## **CARMELDA LOT 1 SUBDIVISION**

Engineering Comments: FINAL PLAT COMMENTS (should be addressed prior to submitting the FINAL PLAT for review and/or signature by the City Engineer):

APPLICATION NUMBER 2 DATE October 4, 2018

# DETAIL SITE PLAN

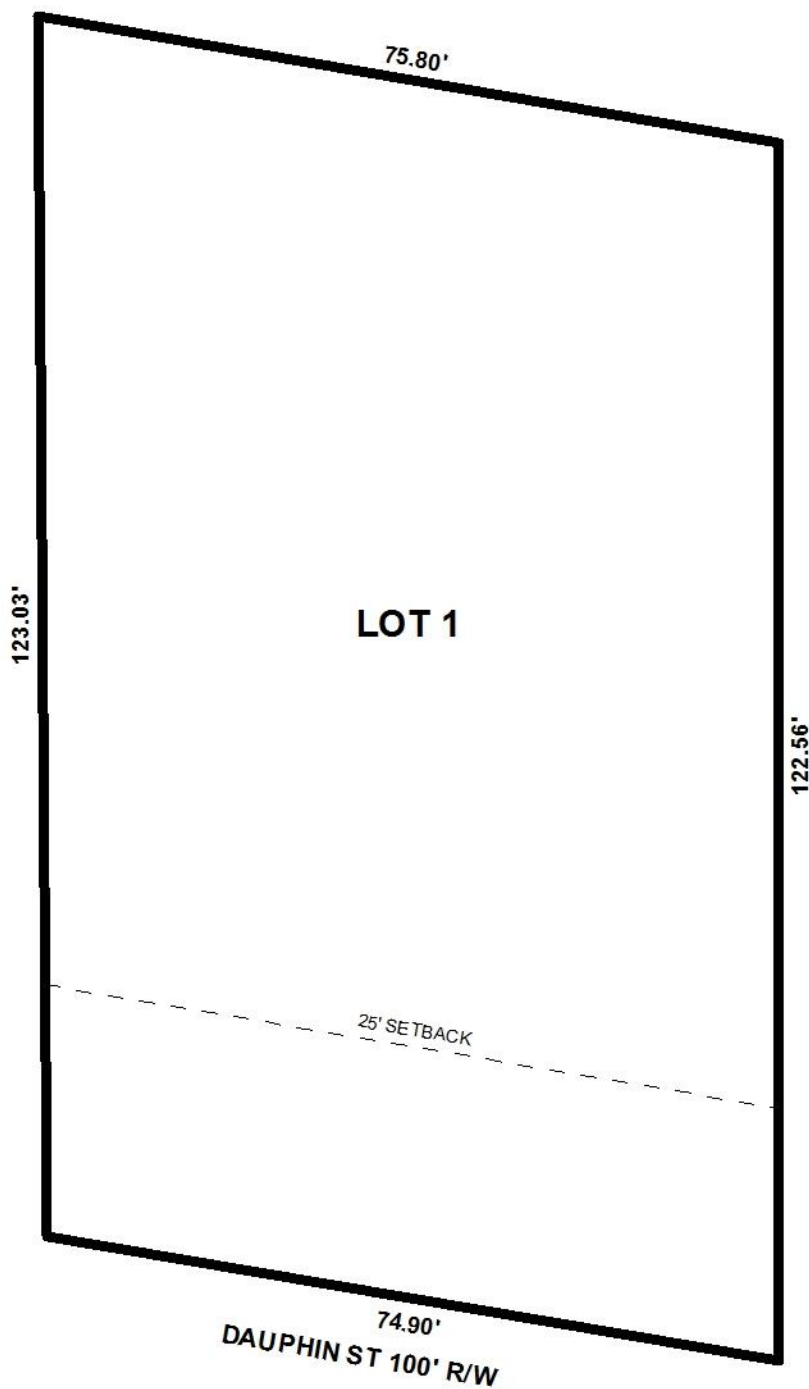
The proposed lot fronts Dauphin Street, a major street on the Major Street Plan. The preliminary plat illustrates a compliant 100’ right-of-way width on Dauphin Street and, if approved, should be retained on the Final Plat.

A 25-foot minimum building setback line along Dauphin Street is depicted on the preliminary plat. If approved, the 25-foot setback should be retained on the Final Plat.

The proposed lot exceeds the 7,200 square foot minimum lot size requirements for lots served by public water and sanitary sewer systems. The preliminary plat provides the lot size in square feet and acres. If approved, the lot size information should be retained on the Final Plat.

As a means of access management, a note should be placed on the Final Plat, stating that Lot 1 is limited to its existing curb cut to Dauphin Street with any changes in size, location and design to be approved by Traffic Engineering and conform to AASHTO standards. Any new on-site parking, including ADA handicap spaces, shall meet the minimum standards as defined in Section 64-6 of the City's Zoning Ordinance.

- 1) Retention of the 100' right-of-way width to Dauphin Street;
- 2) Retention of the 25' minimum building setback line along Dauphin Street;
- 3) Retention of lot size information in both square feet and acres;

- 5) Placement of a note on the Final Plat stating the following Traffic Engineering comments:: (*Lot is limited to its existing curb cut to Dauphin Street with any changes in size, location and design to be approved by Traffic Engineering and conform to AASHTO standards. Any new on-site parking, including ADA handicap spaces, shall meet the minimum standards as defined in Section 64-6 of the City's Zoning Ordinance.*);
